Access Compliance Report Public Rights-of-Way (Curb Ramps)

Main Street: WHITNEY_DR Cross Street: LAURINDA_WY Location: NW

ADA ID: RPAT211001120542 Ramp Type: Type 1 - Perpendicular Diagonal Initial Pass/Fail: Pass Overall Compliance: No Severity Score: 22

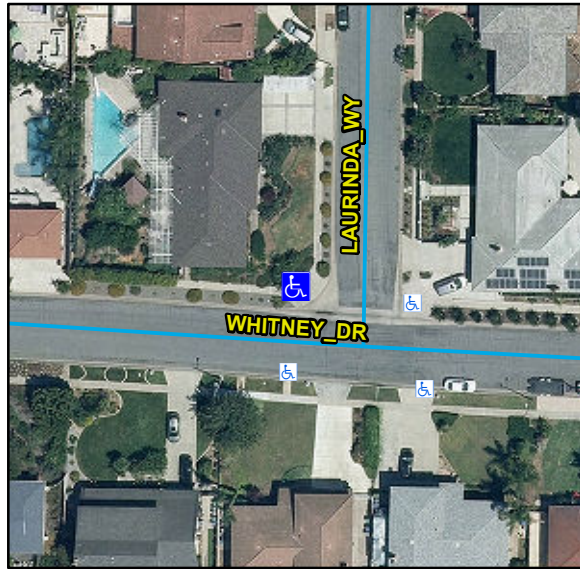
Possible Solutions:

Remove & Replace Curb Ramp With Two New Directional Ramps or Equivalent.
